Intel Technical Advisory

TA-0946-1

Intel® Server System SR1630HGP SGPIO Cable May Be Plugged Into Wrong Connector

Figure 1 Correct SGPIO Cabling Installation

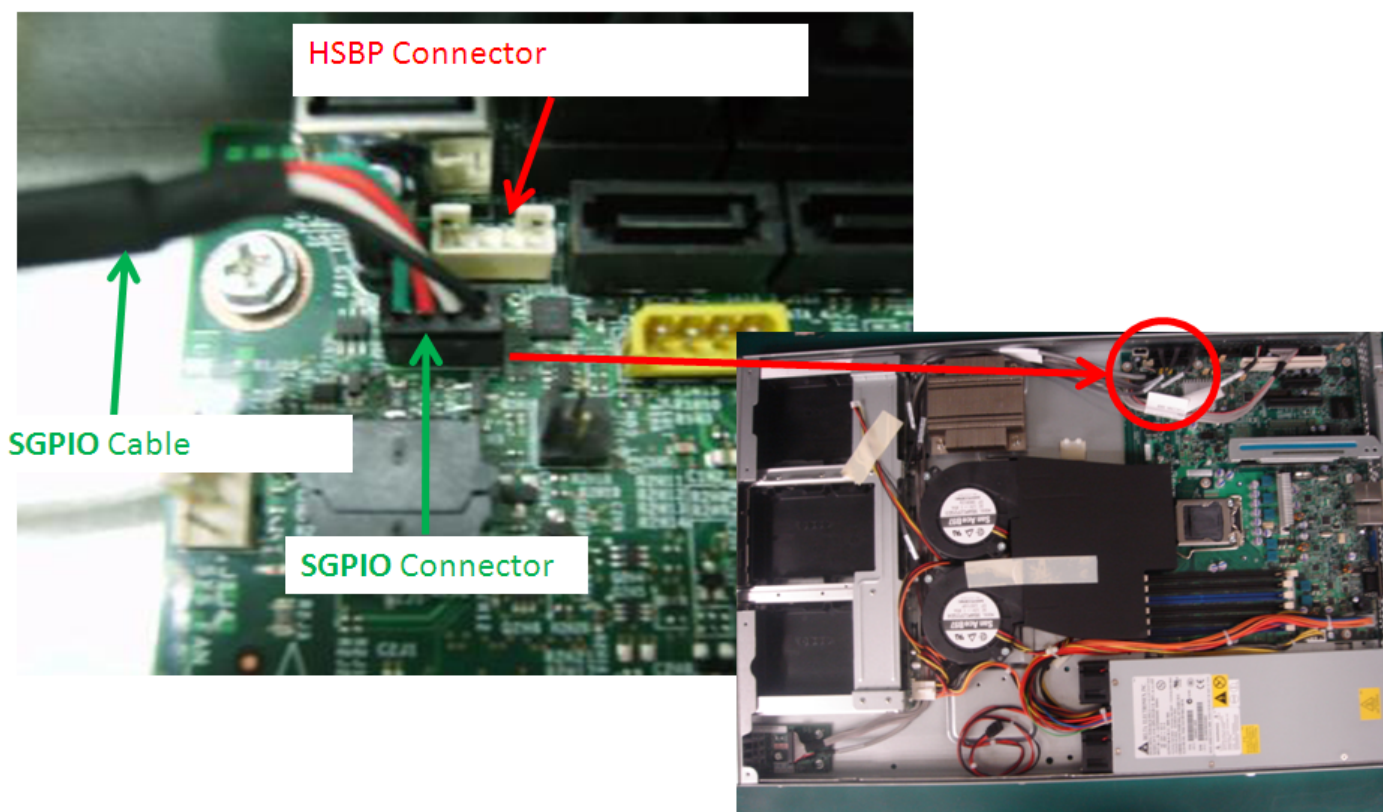
Intel has discovered an issue with the server products listed above in which the SGPIO cable is plugged in the wrong connector on the server board. The SGPIO cable should be plugged in the black SGPIO connector. But in some systems the SGPIO cable was incorrectly plugged in the white HSBP (Hot Swap Backplane) connector. These two connectors are pin compatible; therefore different colors are used to distinguish the connectors. Figure 1 shows the SGPIO cable when it is correctly plugged into the black SGPIO connector.

Customers can check the HDD Activity LED light behavior. If any of the LED's are unexpected lit and the system built date was before WW11, 2010, customers may refer to the Figure 1 to check the SGPIO cable connection and correct it accordingly. For the top cover disassembly procedure, please refer to Intel® Server System SR1630HGP Quick Start User's Guide on the Intel® Server Deployment Toolkit CD or at <http://www.intel.com/support/motherboards/server/s3420gp/sb/CS-030745.htm>.

Figure 2 HDD Activity LED location

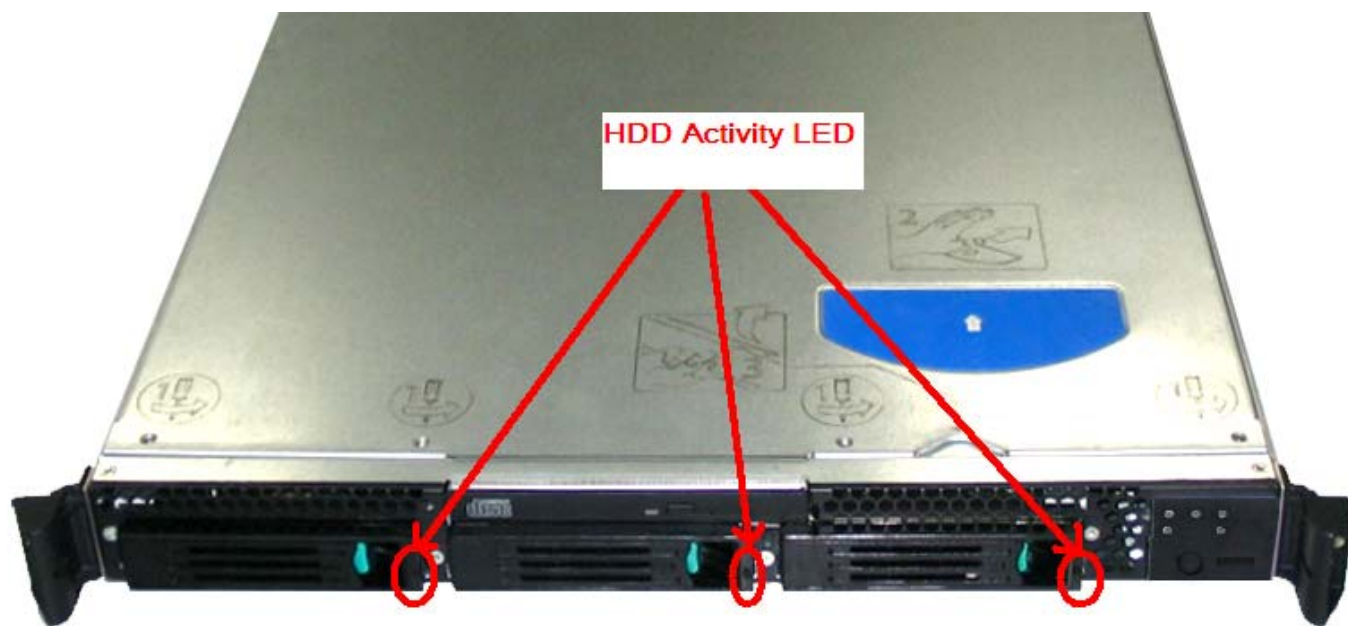
When the SGPIO cable is mistakenly plugged into the HSBP connector, the Hard Disk Drive (HDD) activity LED from the hot swap slot could light up unexpectedly. These three HDD activity LEDs (either amber or green) may incorrectly be lit and stay on.

Figure 3 System Serial Number Sticker Location

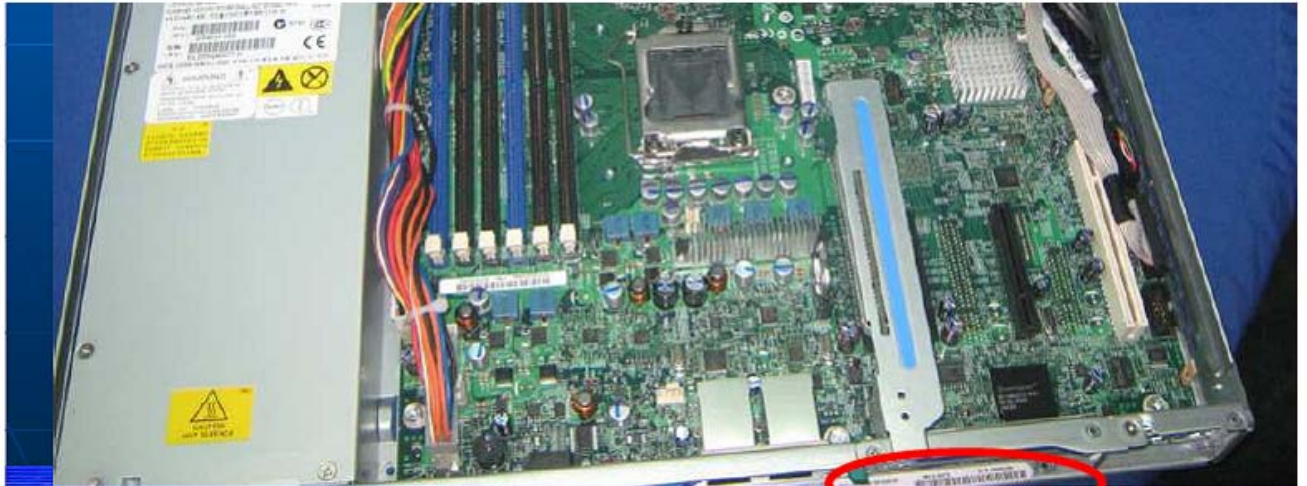
Intel implemented corrective action in the factory assembly line starting with products carrying the system Serial Number AZGY0110001 and later. Please refer to Figure 3 and 4 for the location and definition of the Serial Numbers.
